D7.6 Report on conservation compatibility of the developed solutions and methods

**[Compatible solutions for improving the energy efficiency
of historic buildings in urban areas]**

Project Acronym	3ENCULT
Project Title	Efficient ENergy for EU Cultural Heritage
Project Coordinator	Alexandra Troi EURAC research, Viale Druso 1, 39100 Bolzano/Italy Alexandra.troi@eurac.edu
Project Duration	1 October 2010 – 31. March 2014 (42 Months)

Figure 2.3: Down spout of the roof

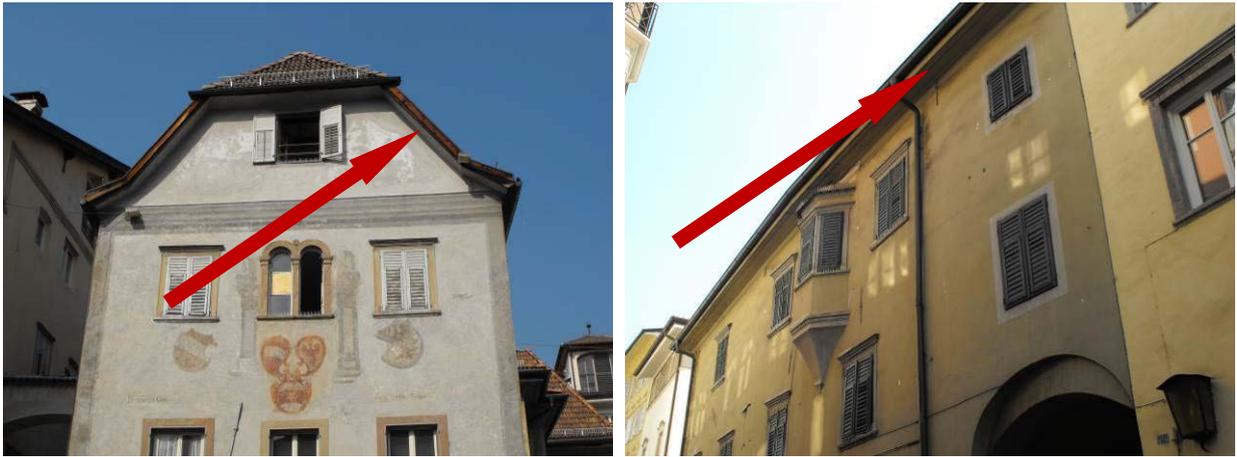
- Not only the appearance of the roofage has to be kept, also the lower side of the roof (down spout) can't be changed by f. e. rising the roof covering, in case of putting insulation of the roof above the rafters. The profile and the proportions of the roof-edge should be preserved.

Figure 2.11: Dimensions of the bay window: window frame, exterior reveals and wooden frame on the outer side for fixing the window shutters

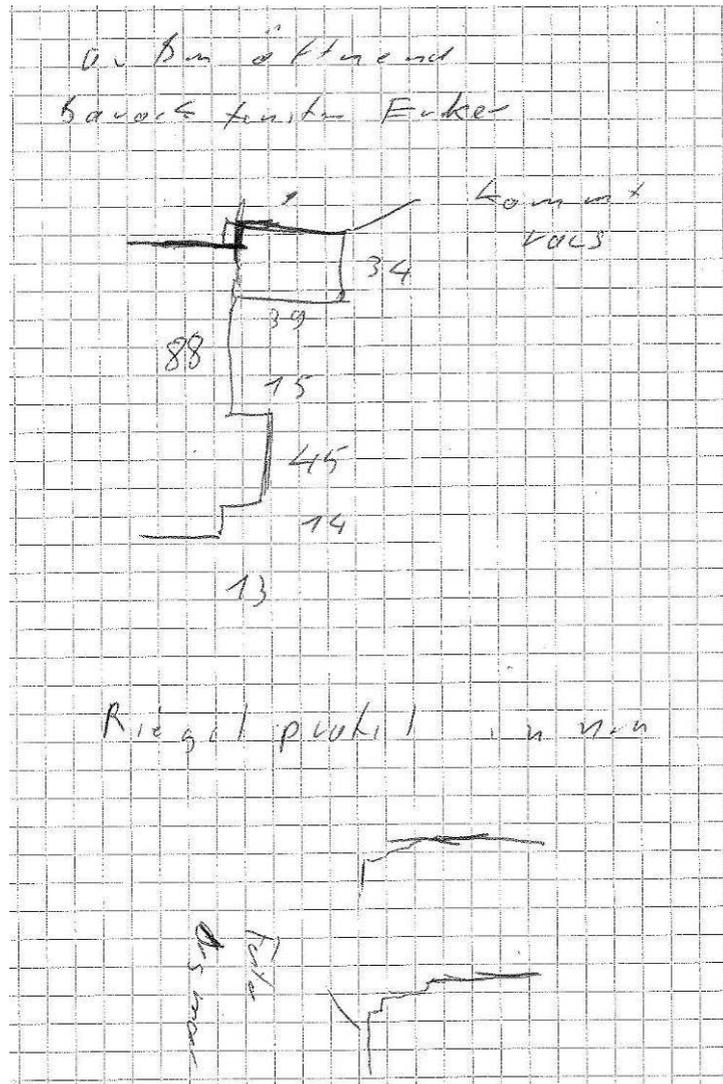
- Solution: removing the existing wooden frame outside, which serves for the fixing of the window shutters. Instead of the wooden frame outside provide a second window layer, which takes over the energy efficient function (concept of the composite window prototype “upside down”). The outer wing can be opened to the outside; it can be executed without the horizontal impost (only one sash).

- The refurbishment solution for the bay windows should serve as an example for an individual case, which means a case where the original window should be preserved and where a solution for energetic improvement must be found individually. The solution should be developed in terms of drawings and heat-transfer calculations (in THERM) to the extent that they are executable. There will be no prototype built for this case.

Figure 2.13: Drawings of the second window prototype for the Public Weigh House (above) and the prototype for a typical box-type window of Bolzano (below)

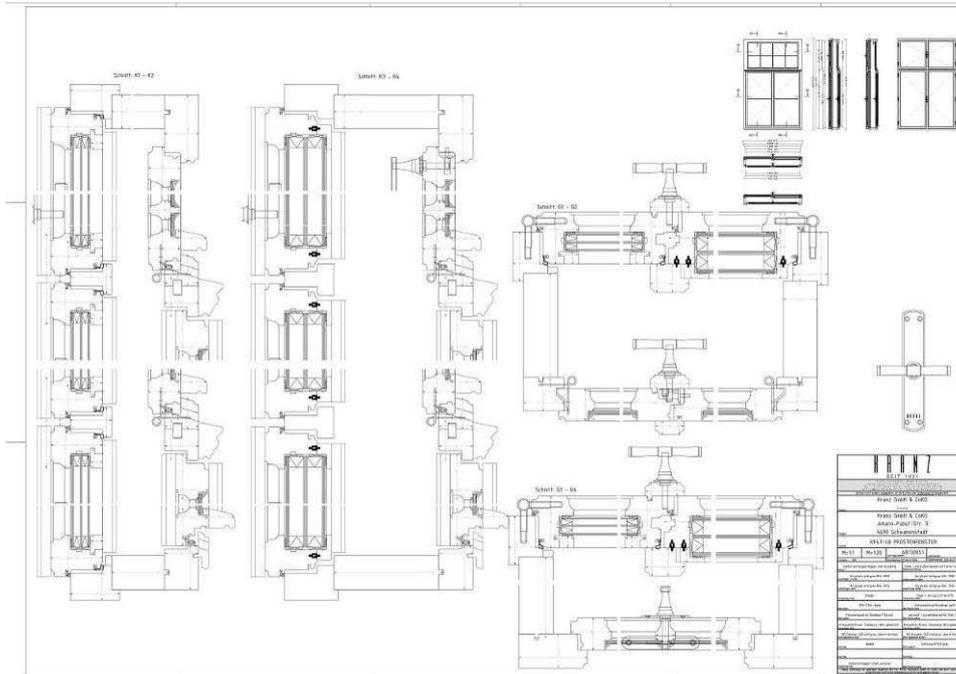
Comment of the conservator with regard the coupled window for the Public Weigh House:

- Colour of the silicone joints: should also correspond to colour of the respective frame
- Type of window handle: same as on the drawing. The size of the handle is suitable, the “Schild” should be smaller. As material brass shouldn’t be used.

- Single glazing outside: “Restauro leicht”
- Triple glazing inside: still questionable from aesthetical and functional point of view
- Type of wood: local timber: pine or larch. Since the wood is varnished spruce is more recommendable.

- Profiling inside and outside: like in the drawing
- Weatherboard: Production of the weather board on the above and below window sashes in timber (“overlap” at the joint of the two window sashes in metal) -> see drawing

- Horizontal impost: the design of the impost has to be revised. The impost should be a “T-piece” with a profile on the outer side -> see drawing
- Sash bars: the width of the sash bars seems a bit narrow. Please compare the design of the sash bars with that of the first window prototype – the width of the sash bars was suitable in that case. -> The window expert will study a solution where the sash bars are “interrupted” by the glazing.

- Colour of the silicone joints: should also correspond to colour of the respective frame
- Type of window handle: same as on the drawing. The size of the handle and of the “Schild” is suitable. As material brass shouldn’t be used.

- Single glazing outside: “Restauro leicht”
- Triple glazing inside: still questionable from aesthetical and functional point of view
- Type of wood: local timber: pine or larch. Since the wood is varnished spruce is more recommendable.

- Profiling inside and outside: like in the drawing
- Design of the upper window: rebating inside and on the above side tiling to inside
